# and Management Parameters for 10 Mb/s Operation and Associated Power Delivery over a Single Balance

CI 00 SC 0 P L # i-287

[6] Insert a new Figure 145-6 shown below (view using a non-proportional font such as courier), renumbering the following figures as required.

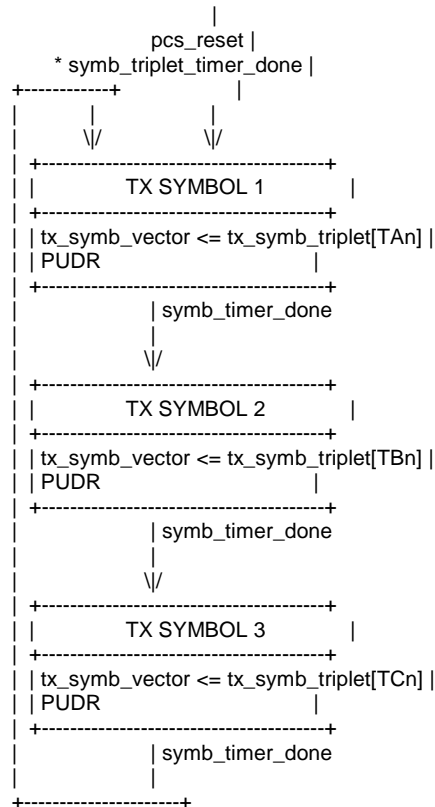
Is it correct that 'The PCS Transmit function shall conform to the PCS Transmit state diagram in Figure 146-5 ...' and that 'In each symbol period, PCS Transmit generates a symbol An provided to the PMA ...'? The PCS Transmit state diagram in Figure 146-5 changes state based on STD being true, with STD being an alias for symb\_triplet\_timer\_done, and the output of the PCS Transmit state diagram is tx\_symb\_triplet which is defined in subclause 146.3.3.1.1 'Variables' as 'A triplet of ternary symbols generated by the PCS Transmit function after 4B3T encoding.'.

I think the problem is that there is another function within the PCS Transmit function that is missing from the PCS Transmit state diagram in Figure 146-5, the 'multiplexor' shown in Figure 146-6 'PCS transmit symbol generation'. This 'multiplexor' function operates at the symbol clock rate and serialises the tx\_symb\_triplet code-groups output by the PCS Transmit state diagram into individual symbols.

This may also explain when subclause 146.3.3.1.3 'Timers' defines the symb\_timer that is not used in the PCS Transmit state diagram in Figure 146-5.

[4] Add a new subclause 146.3.3.2.2 titled 'Timers'. Move the symb\_timer definition from subclause 146.3.3.1.3 Timers to this new subclause.

[7] Add text to subclause 146.3.3 'PCS Transmit' that reads 'The PCS Transmit function shall conform to the PCS Transmit state diagram in in Figure 146-5 and the PCS Transmit multiplexor state diagram in 146-6, and their associated state variables, functions, timers, and messages.'
